TOLEDO - LUCAS COUNTY PLAN COMMISS

SUP25-0034

5820 & 5930 Hagman Rd.

SUBJECT: Amendment to Special Use Permit to raze and rebuild Gasoline and Fuel Sales, originally granted by Ord. 539-80, at 5820 & 5930 Hagman Road.

SITE PLAN

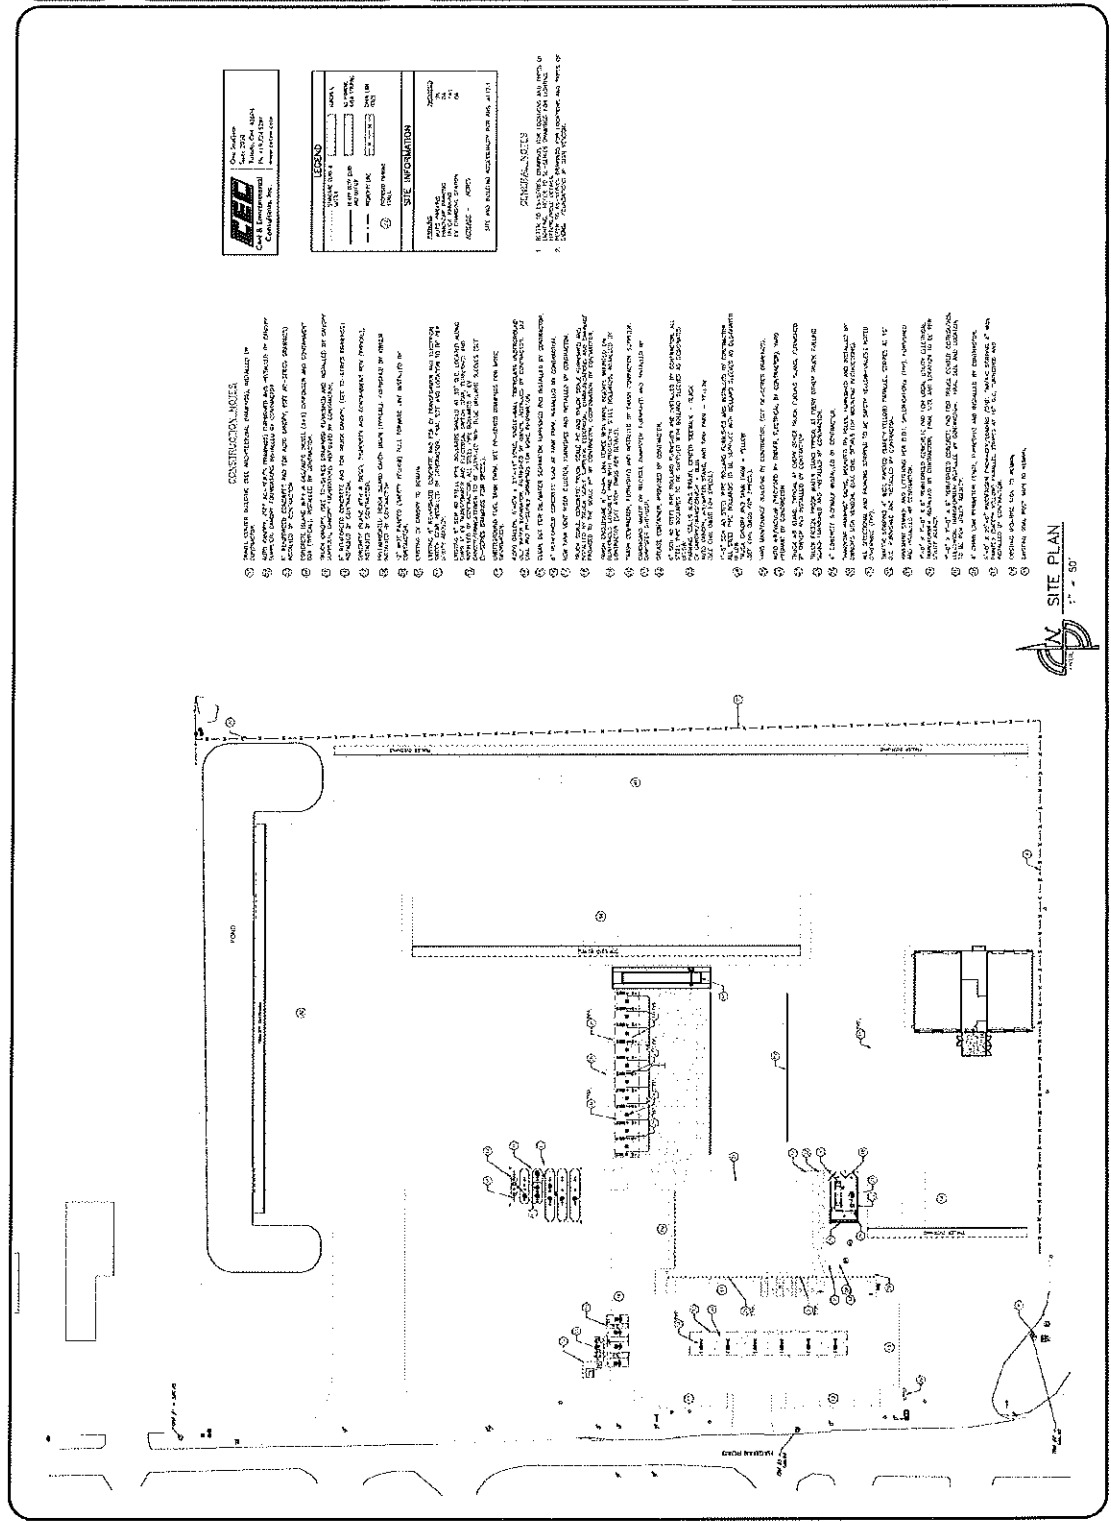
The submitted site plan does not depict the dimensions of drive aisles, maneuvering areas, off-street parking spaces, nor stacking spaces. A revised site plan that clearly defines the dimensions of such items shall be submitted and is subjected to the approval of the Division of Traffic Management. The previously approved Ordinance 539-80, required sidewalk to be installed along Hagman Road however, this condition was never satisfied. Per TMC§1107.1300 and City of Toledo Complete Streets Policy, the condition of sidewalks along Hagman Road shall be upheld and is listed as a condition of approval by the Division of Traffic Management.

The site plan depicts seventy-five (75) auto-mobile parking spaces including four (4) handicap spaces, four (4) electric vehicle spaces; and one hundred forty-one (141) semi-truck parking spaces. Per TMC§1107.0302 based on the estimated square footage of the building, the maximum allowed off-street parking spaces for this site is seventy (70). Pursuant to TMC§1107.1400, an Alternative Parking Plan for excess parking beyond the maximum allowed is required however, the Plan Director has determined the proposed parking is acceptable. The existing Pilot Travel Center currently provides seventy (70) off-street parking spaces. The parking at this site is typically at capacity, and overflow parking of semi-trucks are often found in nearby parking lots of surrounding businesses such as the Meijer grocery store, hotels and fast-food restaurants. The proposed parking for the Pilot Travel Center will help to alleviate semi-truck parking from surrounding businesses and support means of access to the travel center.

Per TMC§1107.0901 bicycle parking shall be provided at a rate of one (1) bicycle parking slot per ten (10) parking spaces. Based on the seventy-five (75) car parking spaces provided, eight (8) bicycle slots are required. The site plan does not depict bicycle parking, a revised site plan depicting bicycle parking shall be submitted and is listed as a condition of approval. Per TMC§1107.1700 - *Accessible Parking*, one (1) van-accessible parking space with an 8-foot aisle abutting the space, and two (2) car-accessible parking spaces with a 5-foot abutting aisle are required based on the proposed parking spaces. The proposed site plan meets this requirement as two (2) car-accessible and two (2) van-accessible spaces are provided.

39. Bicycle parking slots shall be provided per TMC§1107.0304 Schedule A for the proposed gas station. Eight (8) bicycle parking slots are required. **Not depicted, bicycle parking slots shall be provided on a revised site plan.**

43. Site plans shall depict the location and dimensions of drive aisles, maneuvering areas, off-street parking spaces, and stacking spaces. **Not depicted, a revised site plan depicting such items shall be provided and is subjected to the approval of the Division of Transportation.**

45. Five-foot (5') wide connecting walkways to the street sidewalk and to the parking spaces east and north of the primary building shall be provided pursuant to TMC§1109.0103. **Not depicted, a revised site plan shall be submitted.**

FRONT & REAR ELEVATIONS

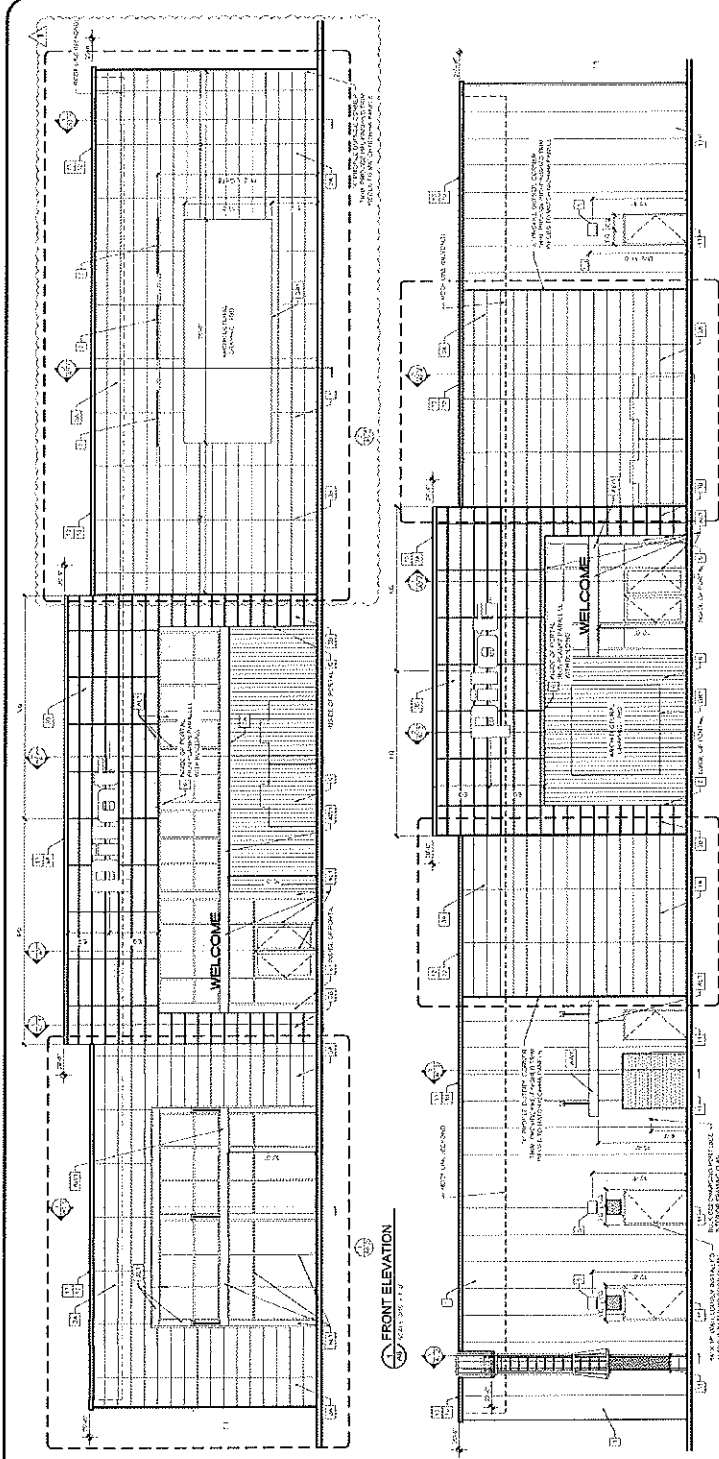
Transparent windows shall occupy at least forty (40%) percent of the area between two (2') and ten (10') feet at grade from the base of the primary elevation (Hagman Road) facing the right-of-way per TMC§1109.0205(C)(3). The proposed elevations depict windows in this area at an estimated coverage of twenty-six (26%) percent. Staff requested the addition of windows along the eastern side of the front façade to meet the forty (40%) percent coverage requirement. The applicant provided floor plans which depicted restroom stalls and showers along this area. Staff has suggested celestial windows that may be opaque along this portion of the façade as a compromise. Revised elevations depicting additional windows along the eastern side of the front façade shall be submitted to the Plan Director for final approval.

The elevations of the proposed building are subject to building material and color standards of TMC§1109.0500. Building material standards apply to all facades that are visible from the right-of-way. Building color standards apply to all exterior elevations regardless of right-of-way visibility. At least eighty percent (80%) of each elevation shall be comprised of predominant building materials and colors; and up to twenty percent (20%) of each elevation may be comprised of accent building materials and colors. This standard applies to the front façade visible from Hagman Road. The proposed front façade is 22% architectural metal, 21% glass, 40% fiber cement board, and 17% metal trim. The proposed architectural metal and glass make-up 43% predominant materials; and the proposed fiber cement board and metal trim make-up 57% accent materials. The proposed elevations do not meet the building material standards of TMC§1109.0500; revised elevations shall be submitted and is listed as a condition of approval.

46. Transparent windows shall occupy at least forty (40%) percent of the area between two (2') and ten (10') feet at grade from the base of the primary elevation (Hagman Rd) facing the right-of-way per TMC§1109.0205(C)(3). **Not acceptable, revised elevations depicting additional windows along the eastern side of the front façade shall be submitted to the Plan Director for final approval.**

47. At least eighty percent (80%) of each elevation visible from the right-of-way shall be comprised of predominant building materials and colors; and up to twenty percent (20%) of each elevation may be comprised of accent building materials and colors. **Not acceptable as depicted, revised elevations that meet the building material standards of TMC§1109.0500 shall be submitted.**

EXTERIOR
ELEVATIONS

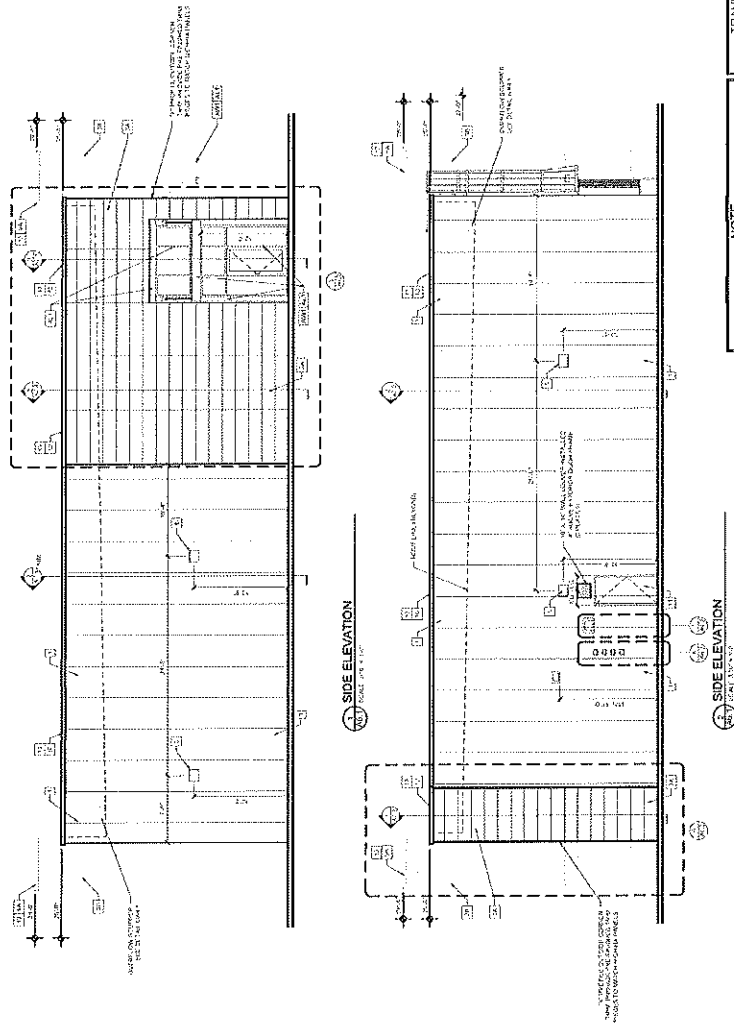
Wall signs are proposed along the front and rear facades of the building. Canopy design and signage have not been proposed, signage on canopies account towards the total allowed area for wall signs. Per TMC§1113.0303, all building signs are limited to a maximum total area of two (2) square feet per one (1) linear foot of building wall frontage facing a public street. Therefore, the signage proposed on the rear of the building is not permitted. Chapter 1113 requires that a sign permit be submitted and approved for all site signage prior to installation. Compliance with Chapter 1113 is listed as a condition of approval.

The Plan Commission recommends **approval** of a waiver to allow for signage on the east facade of the building, which does not face a public street because a primary customer entrance is proposed in this location.
